Project	IEEE 802.16 Broadband Wireless Access Working Group < http://ieee802.org/16 >	
Title	The Passive Multi-hop Relaying HARQ Mechanism	
Date Submitted	2007-04-18	
Source(s)	Wei Ni, Gang Shen, Shan Jin Alcatel-Lucent, Research & Innovation No. 388, Ningqiao Rd., Pudong Jinqiao, Shanghai, P. R. C	Voice: 86-21-50554550 Fax: 86-21-50554554 mailto: wei.a.ni@alcatel-sbell.com.cn
	Fang Liu, Lan Chen, Xiaoming She, Daqing Gu DoCoMo Beijing Lab 7/F, Raycom Infotech Pack Tower A No.2 Kexueyuan South Rd., Haidian District, Beijing, China	Voice: +86-10-82861501 ex.331 Fax: +86-10-82861506 mailto: {liu, gu }@docomolabs-beijing.com.cn
	Fujio Watanabe DoCoMo USA Labs 3240 Hillview Avenue, Palo Alto, CA	Voice: 650-496-4726 mail to: watanabe@docomolabs-usa.com
	Rakesh Taori, Mi-Sun Do Samsung Advanced Institute of Technology	Voice: +82-31-280-9635 mailto: rakesh.taori@samsung.com
	Youngbin Chang, Samsung Electronics 416, Maetan-3dong, Youngtong-gu, Suwon- si, Gyeonggi-do, Korea	Voice: +82-31-270-5519 mailto: yb.chang@samsung.com

IEEE C802.16j-07/252r1

The Passive Multi-hop Relaying HARQ Mechanism

Figure 130jc: The passive MR HARQ mechanism

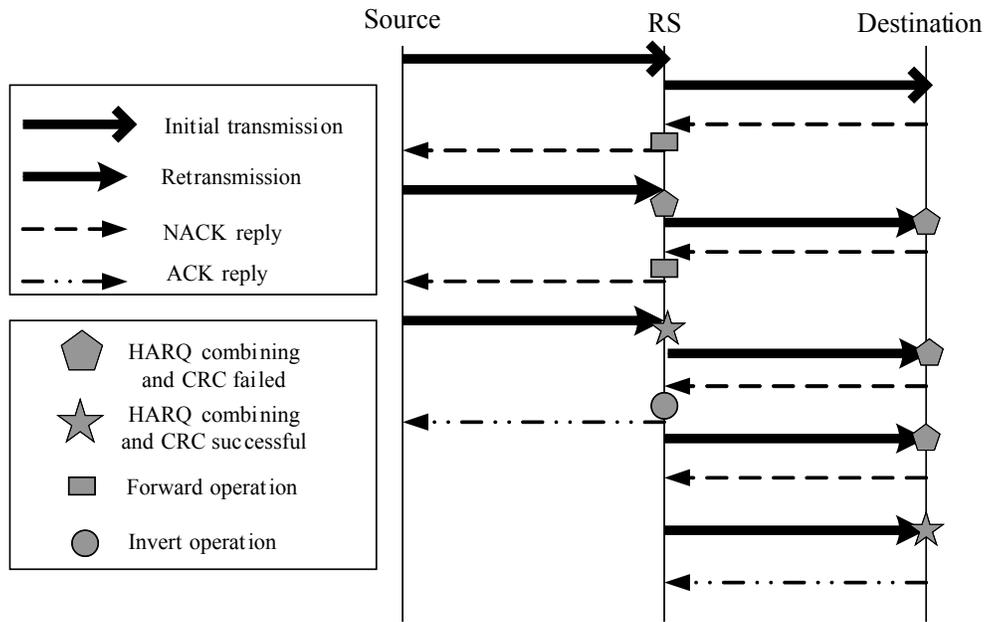
[Insert new sub-clause 6.3.17.4.2 and add figures]

The principle and process of the passive MR HARQ is illustrated in Figure 130jc.

In both uplink and downlink, the source transmits its packets to the RS. The RS forwards the packet to the destination. ACK is sent back to the source via hops from the destination after a fixed delay defined by HARQ_ACK_Delay for UL or DL burst which is specified in DCD message, if the received packet succeeds in the CRC verification. Otherwise, NACK signal is transmitted. The intermediate RSs simply forward the ACK/NACK replies.

Only when a NACK is received for the previous HARQ attempt or an ACK is not received properly, a retransmission is conducted by the source. The intermediate RS performs CRC verification and may perform HARQ combining. If an RS performs HARQ combining and if the combined packet passes the CRC verification, the associated RS sends an ACK signal to the source and the RS may play the role of the source in the following HARQ retransmission attempts. If the CRC verification fails, the RS may forward the erroneous burst to the next hop. When forwarding an erroneous HARQ burst, regardless of the MCS level used for forwarding, the RS shall indicate to the next hop station that the HARQ burst is in error. To indicate the error, the RS modifies the CRC of the packet being forwarded, in such a way that an error is generated at the next hop receiver while verifying CRC.
